SUBMITTAL: AMBASSADOR™ STEEL FIRE EXTINGUISHER CABINETS

ACTIVAR INC. CONSTRUCTION PRODUCTS GROUP AMBASSADOR™ IS A TRADEMARK OF ACTIVAR DOWNLOAD CURRENT SUBMITTAL BEFORE ORDERING	Distributor: Fire Safety, Inc.	Quantity: 19
	Contractor: PARIC Corporation	Approved By:
	Model #: 1015W10	Architect: Cannon Design
	Project: Webster ISB	Date: 4/21/2017 © Activar Construction Products Inc 2016

WEBSTER UNIVERSITY ISB	
PROJECT NAME	
8274 BIG BEND BLVD	
ADDRESS	
NUMBER	
WEBSTER UNIVERSITY	
OWNER	
CANNON DESIGN	
ARCHITECT / ENGINEER	
Joe Voypick	
SUBMITTED BY	
104413-001	
CONTRACTOR / CM SUBMITTAL NO.	CANNON DESIGN SUBMITTAL NO.
	104413
DRAWING / DETAIL REFERENCE	SPECIFICATION SECTION / PARAGRAPH
MANUFACTURER / SUPPLIER	ITEM / PRODUCT ID
REQUIRED DATE	PRIORITY
	CRITICAL

PROJECT: 15051-Webster University Interdisciplinary Science Building

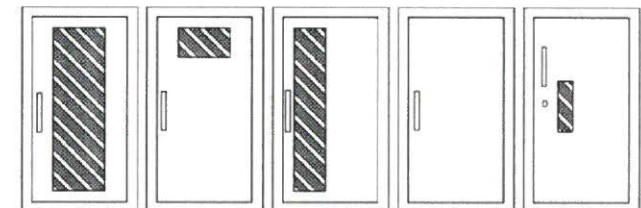
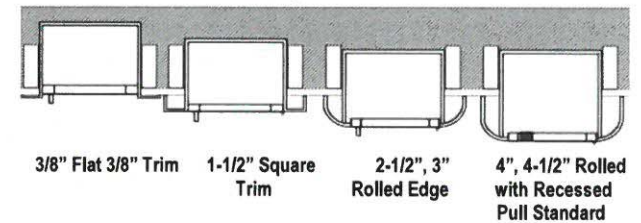
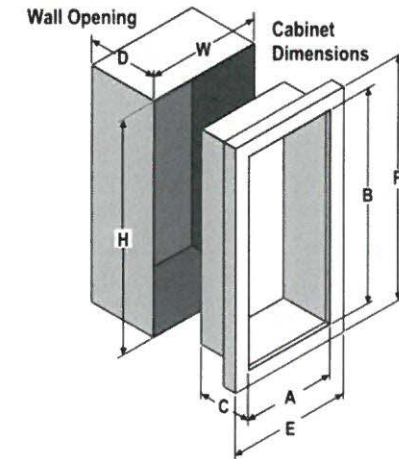
PROVIDE FIRE-RATED CABINETS PER SPECIFICATION 104413, 2.2, B AT FIRE-RATED PARTITIONS.

CONFIRM IF SAF-T-LOK IS ACCEPTABLE WITH WEBSTER UNIVERSITY
